FIELD SERVICE BULLETIN

FSB Number: LVCCFSB2003-100
Author: Tony Bryan
Date: October 17, 2003
Total No. of Pages: 3
Subject: **Triplets Desense Improvement**
Model Affected: V300, V303, V400, V500, V525
Level of Repair: 2

Diagram 1.0 Moon Pad Placement

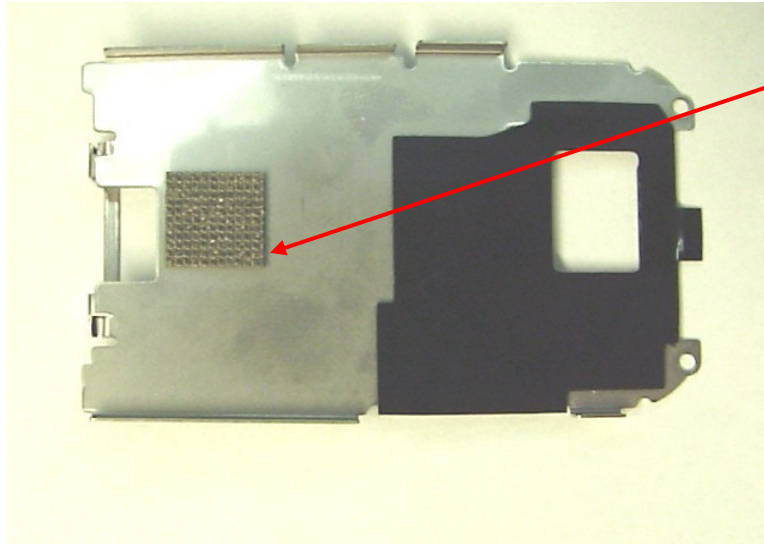
Manufacturing has implemented the placement of a conductive 2mm Moon Pad (3289229N02) centered on the SIM Chassis. The added conductive Moon Pad makes contact with the PCB Shielding and grounds the SIM Chassis to improve Desense performance. Please see Diagram 1.0 below for proper placement of the Moon Pad (3289229N02).

Special Note:
Place grounding pad as shown on Base Chassis, approx. 2 mm from the lower part of the battery contact opening; approx. centered between the sides.

Diagram 2.0 New SIM Chassis Design

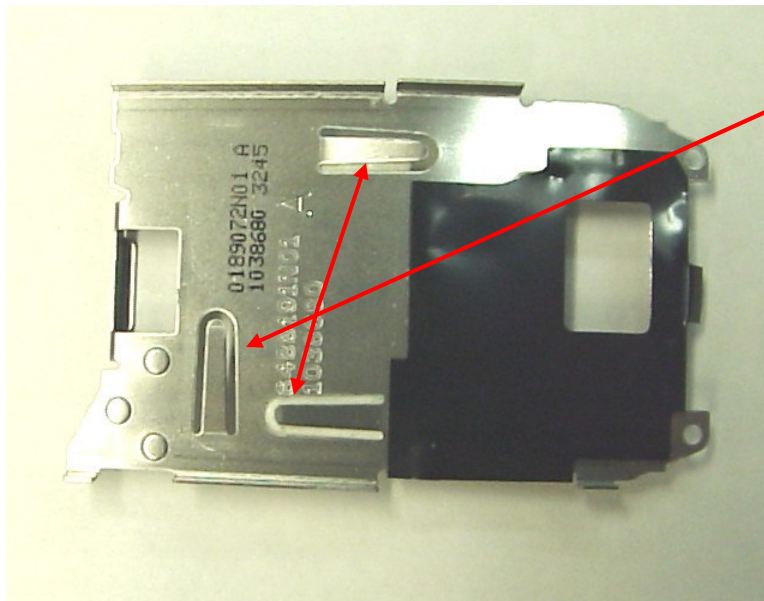
A re-design of the original metal SIM Chassis (0188940N01) has been requested by Hardware Development and will be implemented in manufacturing as soon as material with the new design is available. The new design will include three metal fingers that extend into the housing and make contact with the PCB Shielding adequately grounding the SIM Chassis. Diagram 2.0 below shows a sample of the SIM Chassis with the improved design.

Special Note:
New Design with Three Metal Fingers to GND Chassis
